**SimplexGrinnell #458 & JCI  
9520 10th Avenue South, Suite 100  
Seattle, WA 98108  
RE: Western State Hospital; Lakewood, WA  
318,000 Gallon Bolted STP  
August 3, 2018  
Ms. Melissa Fraser  
Systems Integrity Representative  
(206) 291-1439  
Job No. 318298-A**

## STANDPIPE INSPECTION REPORT

JOB NO: 318298-A INSPECTOR: Christian Costello (LJ)  
TANK OWNER: Western State Hospital  
OWNER'S REPRESENTATIVE: SimplexGrinnell #458 & JCI; Ms. Melissa Fraser  
TITLE: Systems Integrity Representative  
MAILING ADDRESS: 9520 10th Avenue South, Suite 100, Seattle, WA 98108  
PHYSICAL ADDRESS: 9520 10th Avenue South, Suite 100, Seattle, WA 98108  
E-MAIL: Melissa.fraser@jci.com  
CITY, STATE: Seattle, WA ZIP: 98108 COUNTY: Pierce County  
TELEPHONE: (206) 291-1439 FAX: (206) 291-1500  
LOCATION OF TANK: Western State Hospital; 9601 Steilacoom Blvd. SW, Lakewood, WA 98498

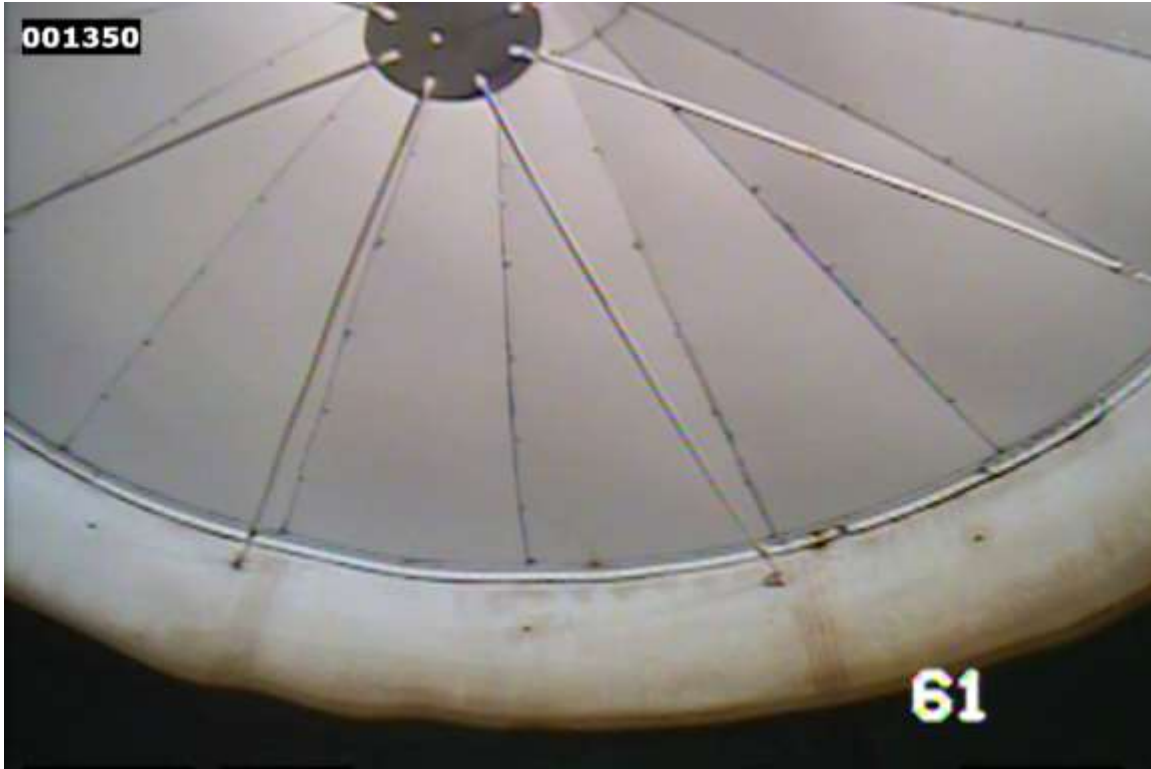
Photo shows the condition of the spider rods and hub assembly. The assembly does not affect the structural integrity of the tank, it was for erection purposes only. We recommend removing the spider rod assembly from the tank.

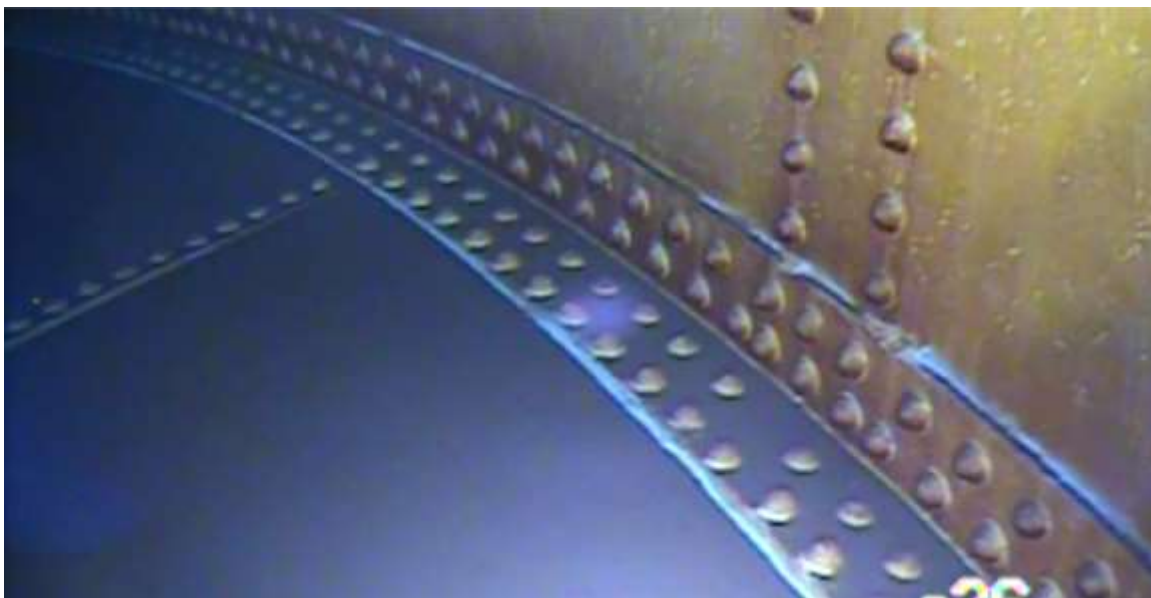
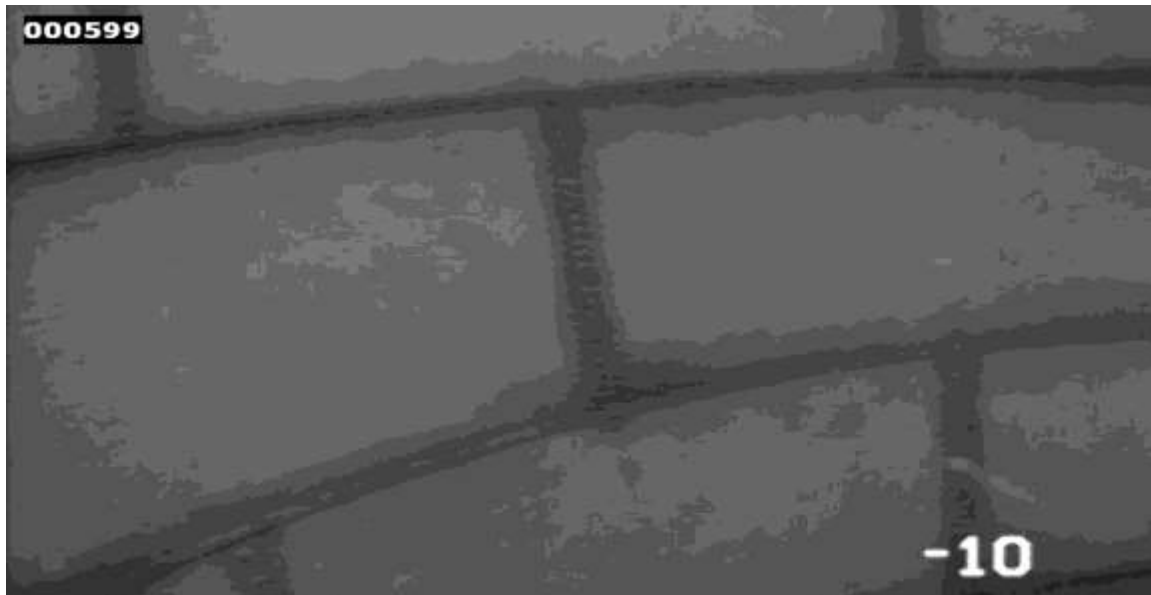
Photos show sediment and debris in the tank interior prior to the performance of the tank clean out.
